**PREVOST**

**SAFETY  
RECALL**

SR12-26

<b>DATE :</b> JULY 2012	<b>SECTION :</b> 06-ELECTRICAL
<b>SUBJECT :</b> PROTECTION AGAINST POWER CABLE RUBBING

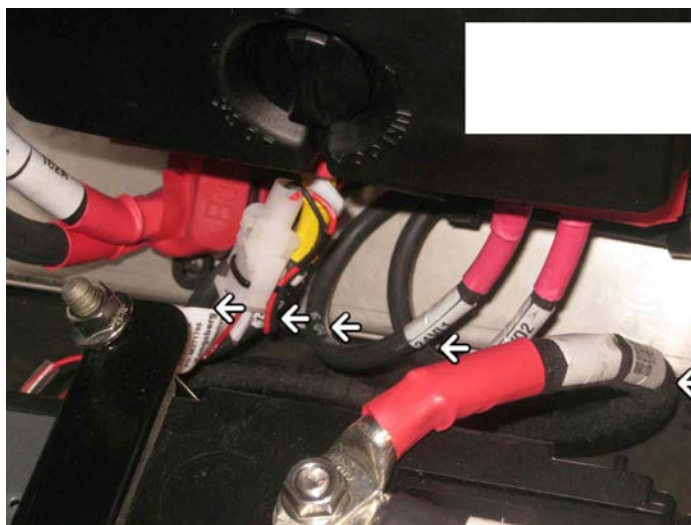
1. In the rear electrical compartment, locate the panel lower edge.

2. No cable should touch this edge even if it is rounded.

Along the complete edge, make sure that no cable touches it.

If required, use cable ties to route cables away from the edge.

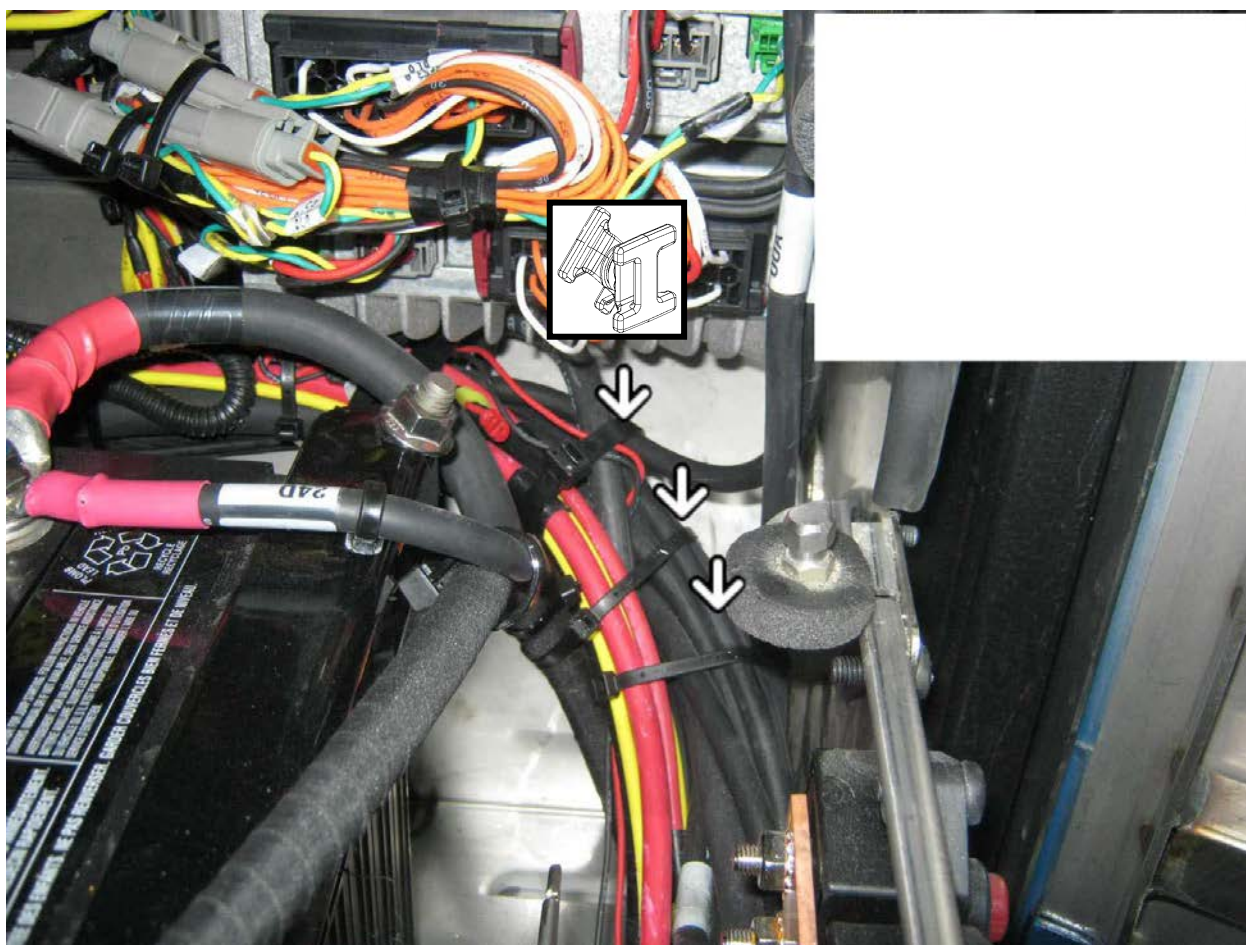
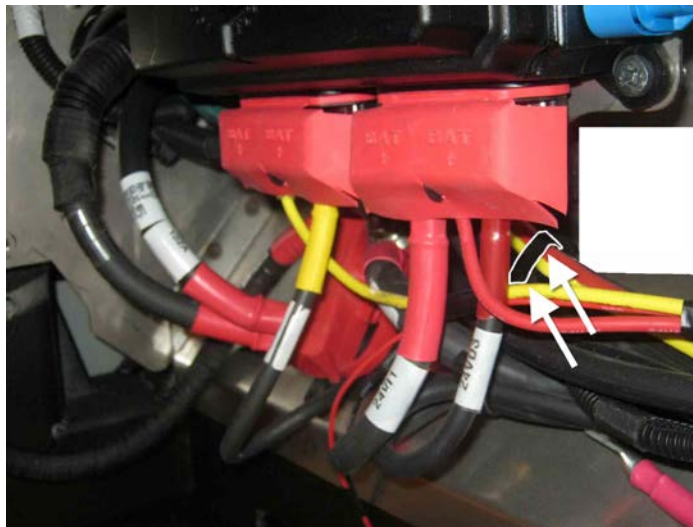
3. Make sure this cable tie is tight (arrows). It is mounted on a cable tie base.

Secure cable bundle at arrow locations making sure to clear the heat sink of the IO module.

Install #504751 double swivel cable tie base with 509491 cable tie on cable bundle.

Base should be installed behind the bundle and bearing on the edge.

Use base as a permanent spacer to maintain a distance from the edge.

Secure the remainder of the bundle with 504016 cable ties.
